Project	IEEE 802.16 Broadband Wireless Access Working Group < <u>http://ieee802.org/16</u> >		
Title	MSS's buffer capability negotiation for DL H-ARQ operation		
Date Submitted	2004-11-17		
Source(s)	kang-gyuLee, yunsungKim, sajinKim, jae-hwanChang, yunsangPark, Jaehee Cho, Geunhwi Lim,	leekg@samsung.com tseliot@samsung.com sj.kim@samsung.com jaehwan.chang@samsung.com yunsang.park@samsung.com	
Re:	This contribution is for call for contribution about IEEE P802.16e/D5-2004		
Abstract	This contribution proposes the MSS buffer capability information for H-ARQ.		
Purpose			
Notice	This document has been prepared to assist IEEE 802.16. It is offered as a basis for discussion and is no binding on the contributing individual(s) or organization(s). The material in this document is subject to chang in form and content after further study. The contributor(s) reserve(s) the right to add, amend or withdramaterial contained herein.

SS's HARQ buffer capability negotiation for DL H-ARQ operation

Figure 1. H-ARQ procedure with MAC buffer capability signaling

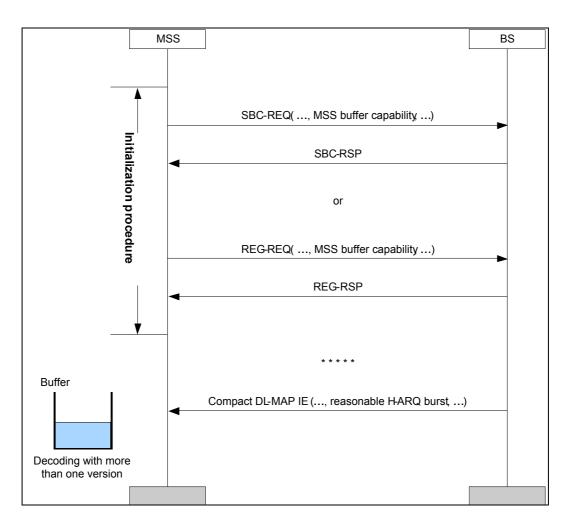
Add the parameter 'MSS buffer capability' into (M)SS Capability encodings which may be included in SBC-REQ/SBC-RSP or REG-REQ/REG-RSP messages. The H-ARQ enabled MSS informs the BS of its buffer capability during initialization procedure as follows.
